UNITED STATES PATENT AND TRADEMARK OFFICE

APPLICATION NO.	FILING DATE	FIRST NAMED INVENTOR	ATTORNEY DOCKET NO.	CONFIRMATION NO.
09/882,164	06/15/2001	Steponas Dziugys	67064	9384

Office Action Summary	Application No. 09/882,164	Applicant(s) DZIUGYS ET AL.	
	Examiner Douglas A. Hess	Art Unit 3651

DETAILED ACTION

FIG. 1

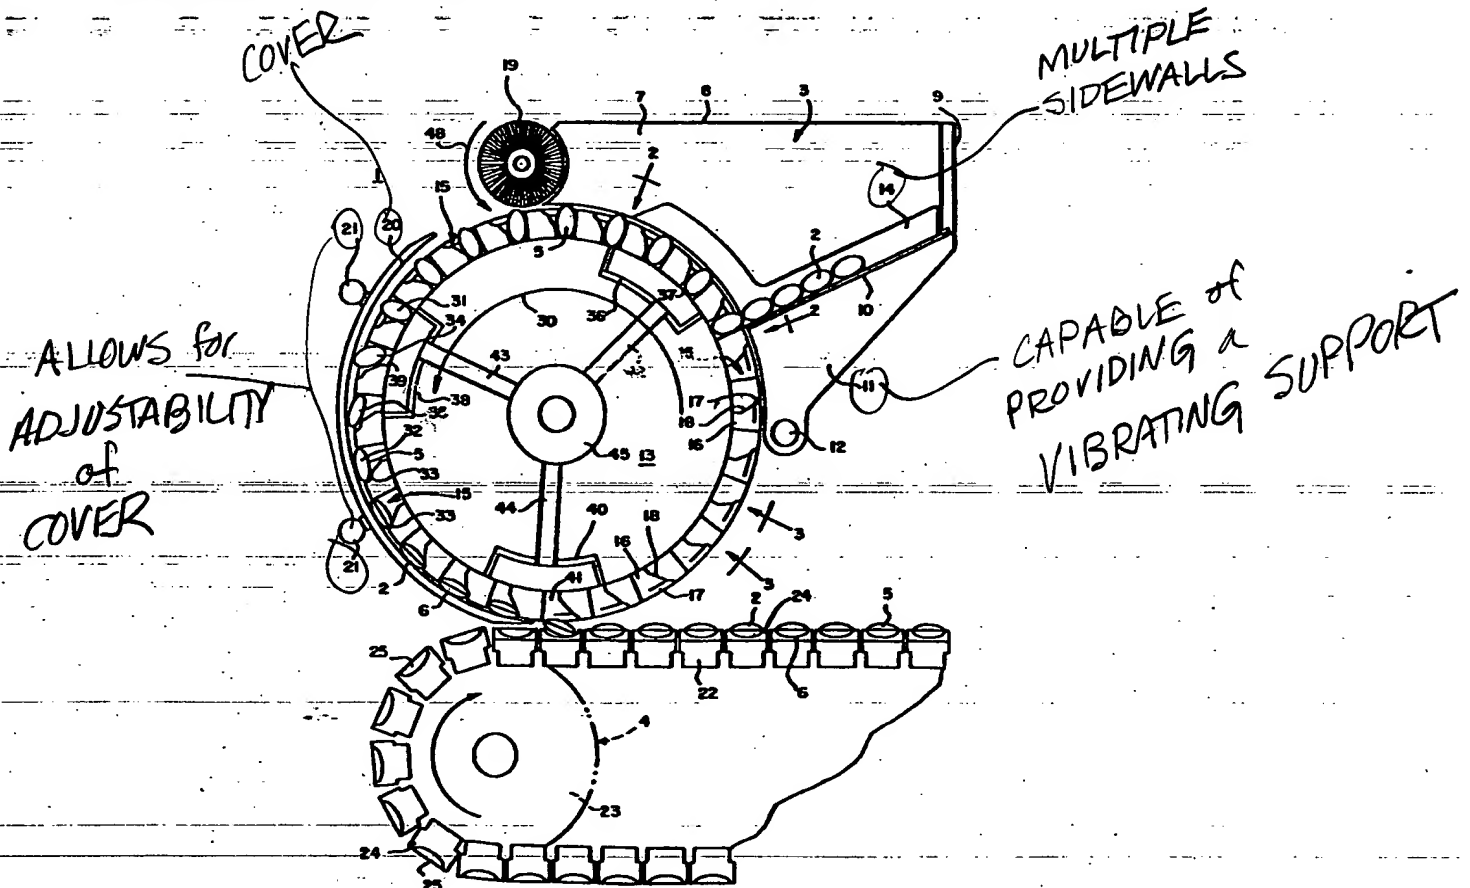
Boyce et al. Teaches the claimed invention as outlined above. Boyce fails to disclose the adjustable cover, the claimed sidewalls, and the vibrating support. Ackley teaches similar apparatus as Boyce, Ackley’s device (see attached marked up cover sheet of Ackley) does disclose sidewalls 14, a support 11 capable of providing a vibration, and an adjustable connection 21, 21 for his cover 20.
